**HORIZONTAL DIRECTIONAL DRILL ANALYSIS
WILLIAM PENN AVENUE CROSSING
PADEP SECTION 105 PERMIT NO.: E11-352
PA-CA-0023.0000-RD and PA-CA-0023.0000-RD-16
(SPLP HDD No. S2-0070)**

**WILLIAM PENN AVENUE CROSSING
PADEP SECTION 105 PERMIT NO.: E11-352
PA-CA-0023.0000-RD and PA-CA-0023.0000-RD-16
(SPLP HDD No. S2-0070)**

CAMBRIA COUNTY, PENNSYLVANIA - JACKSON TOWNSHIP
S2-0070-16

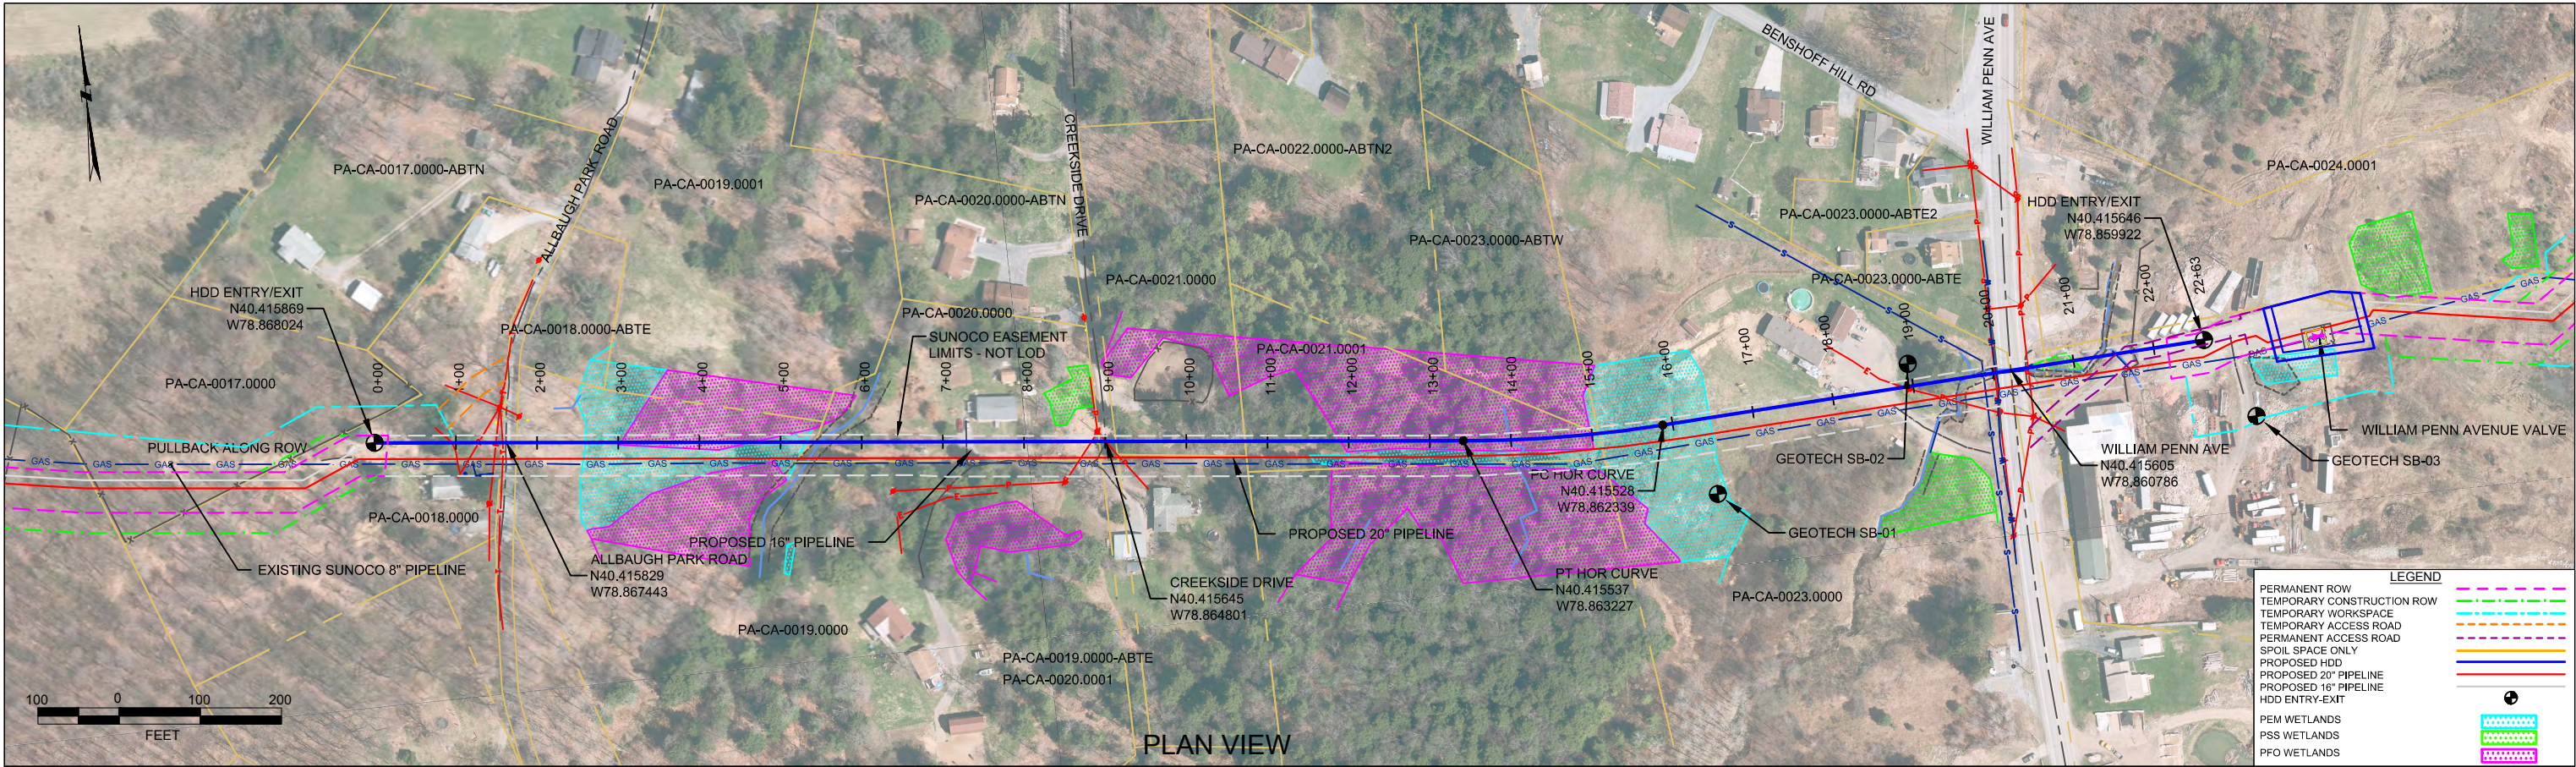
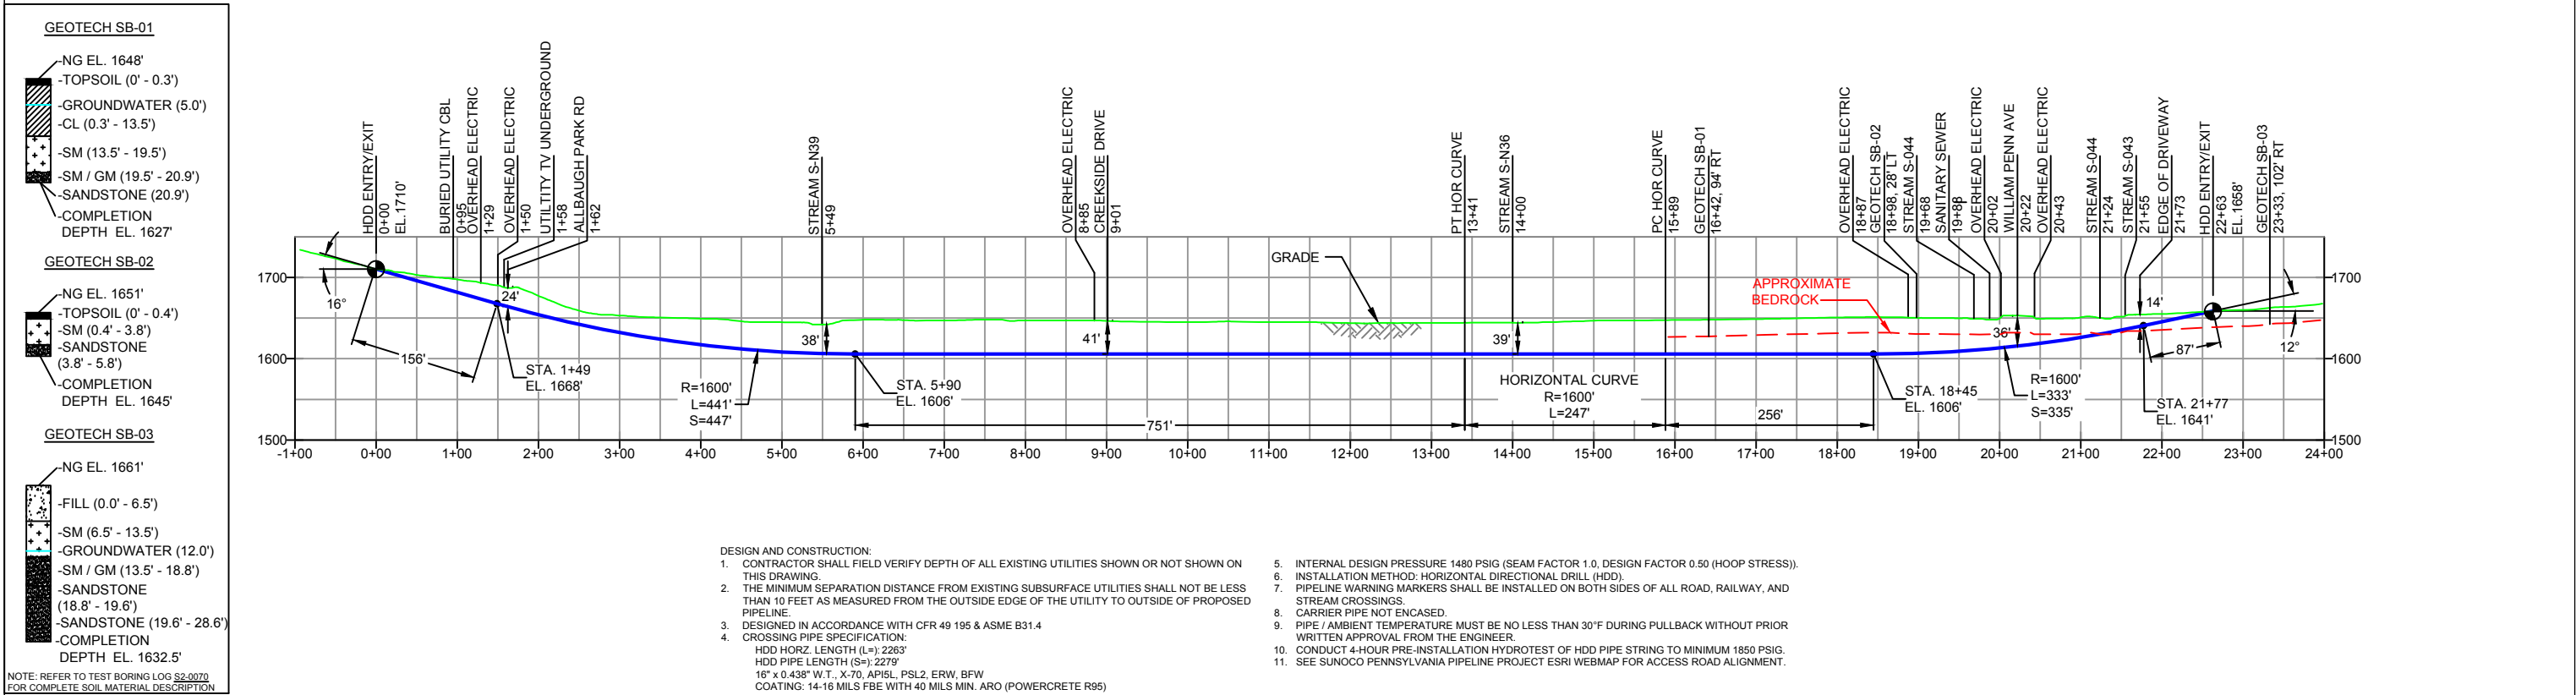
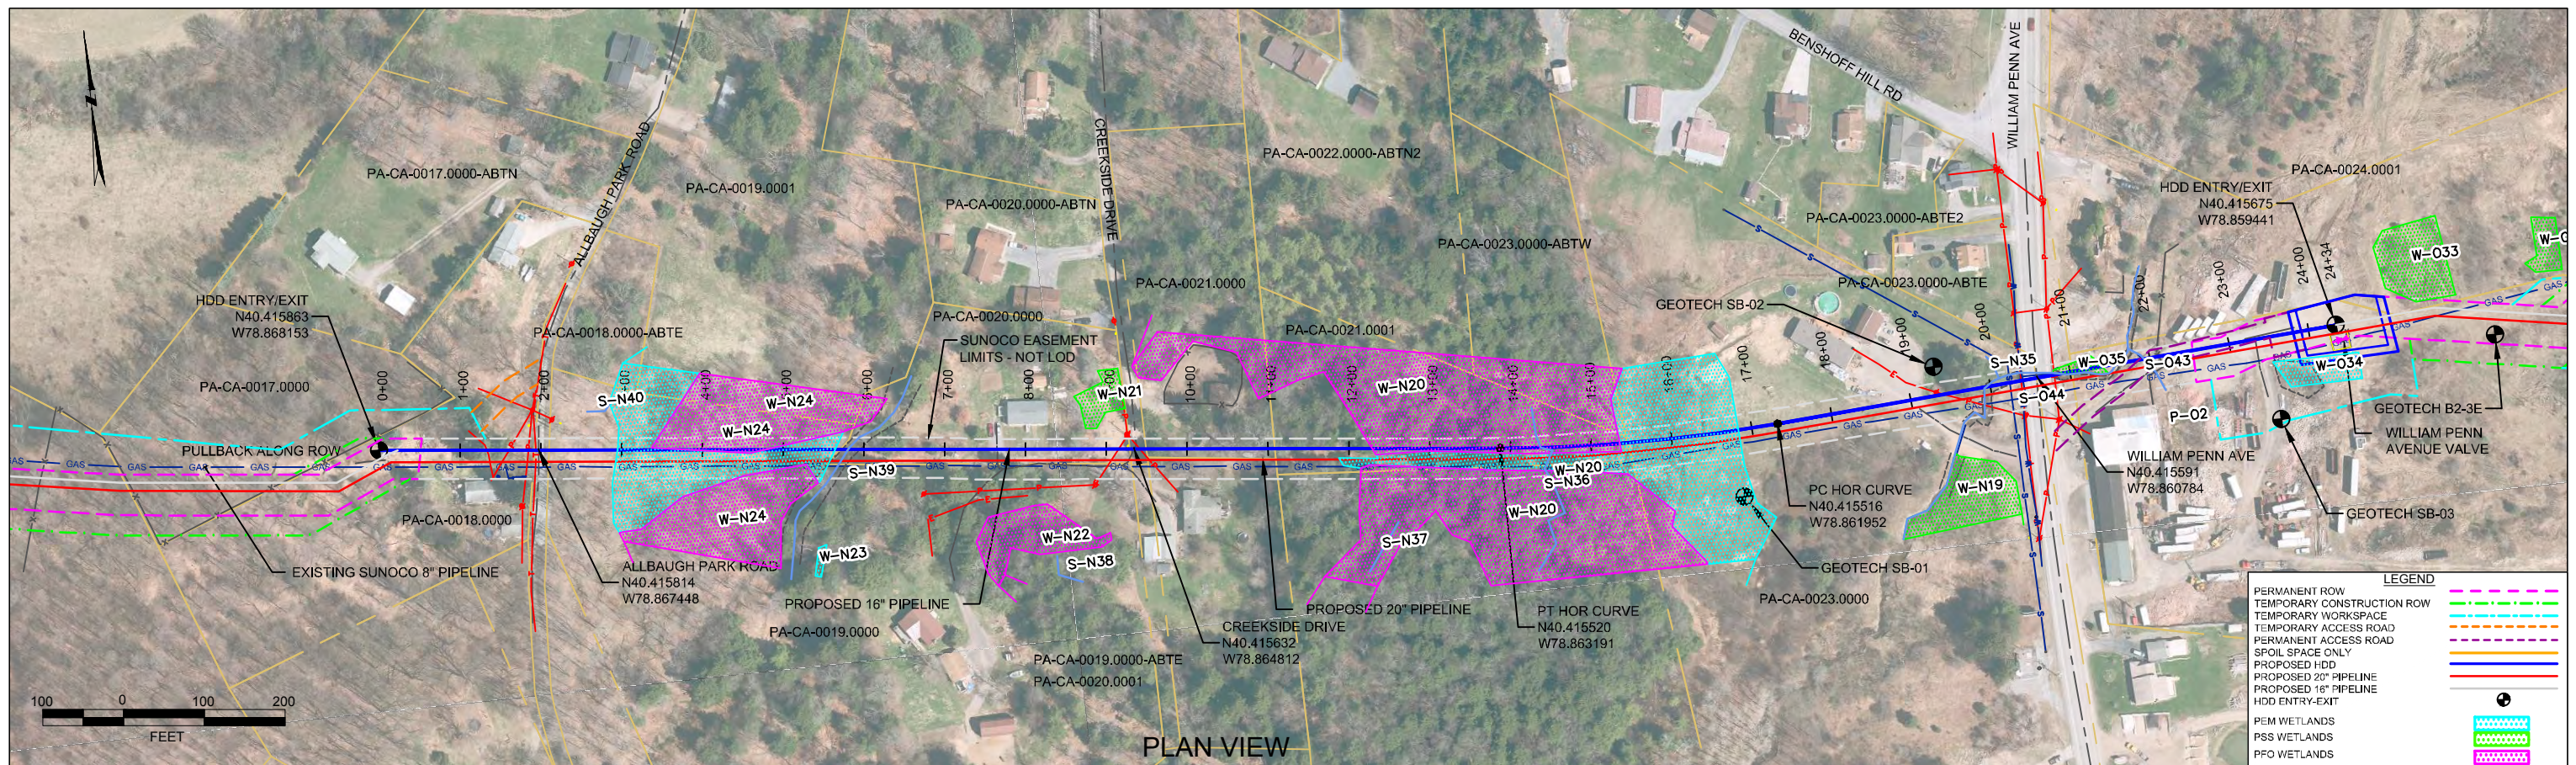
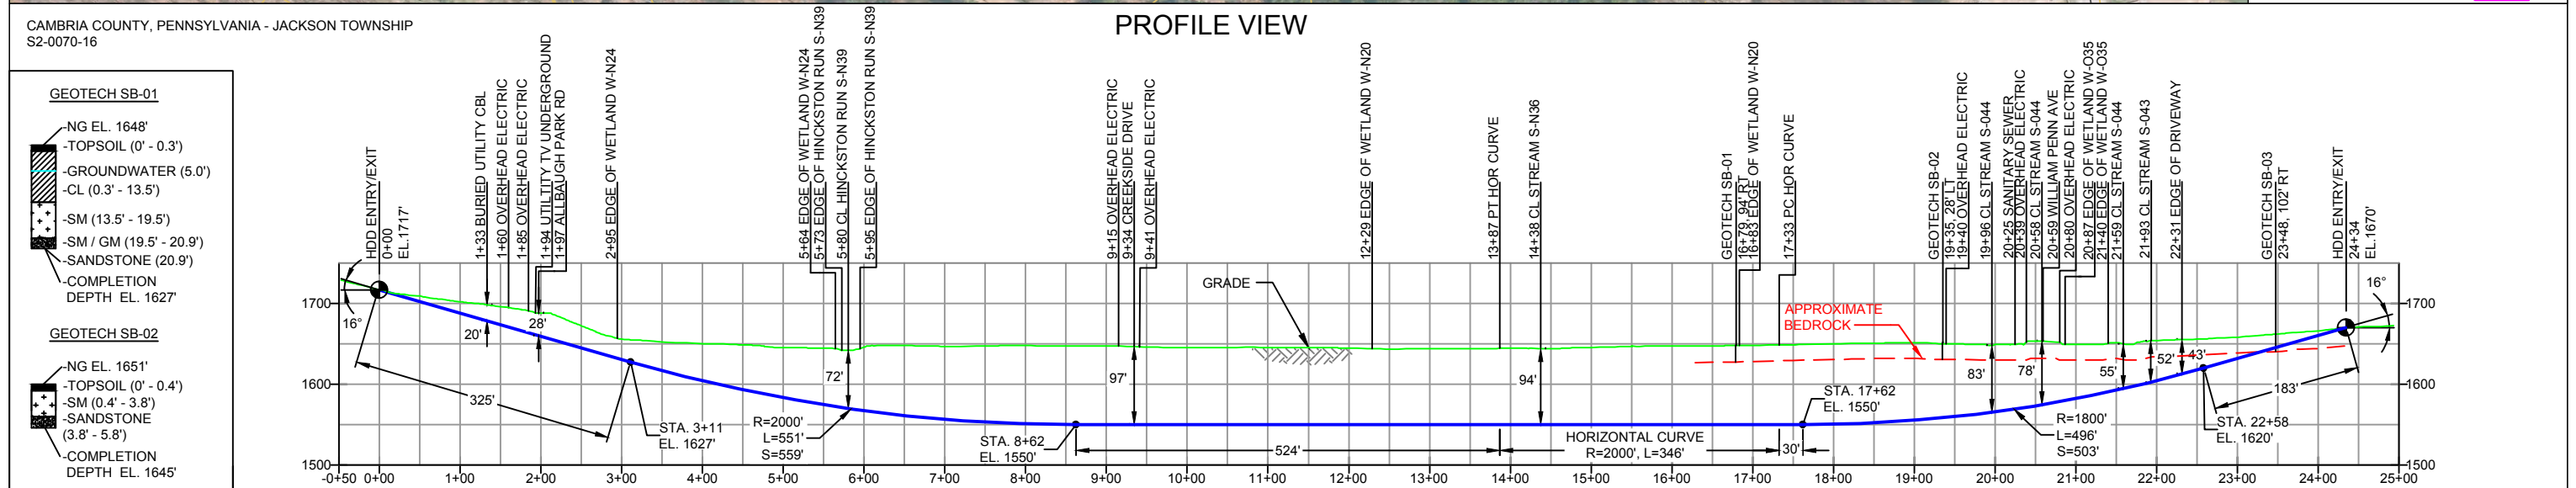
The redesigned HDD profile for the 20-inch pipeline is 228 ft longer, with a depth of cover below the streams and wetlands increased by 14-38 ft from the permitted design. In addition, the entry/exit angles have been increased allowing for a sharper and quicker descent into more competent rock. The redesigned HDD profile for the 16-inch pipeline is 171 ft longer, with a depth of cover below the streams and wetlands increased by 20-47 ft and designed for a sharp and quick entry and exit from the horizontal depth.

It is SPLP's intent to modify the original profile design and to pursue a deeper and longer HDD profile. Figure 1 and 3 in Attachment 3 presents the original HDD plan and profiles. Figure 2 and 4 in Attachment 3 present the revised HDD plan and profiles.

Revised Horizontal Directional Drill Design Summary: 16-inch

- Horizontal length: 2,434 ft
- Entry/Exit angle: 16 degrees
- Maximum Depth of cover: 97 ft
- Depth under William Penn Ave: 78 ft
- Depth under streams: 52-72 ft
- Depth under wetlands: 40-96 ft
- Pipe design radius: 1,800-2,000 ft
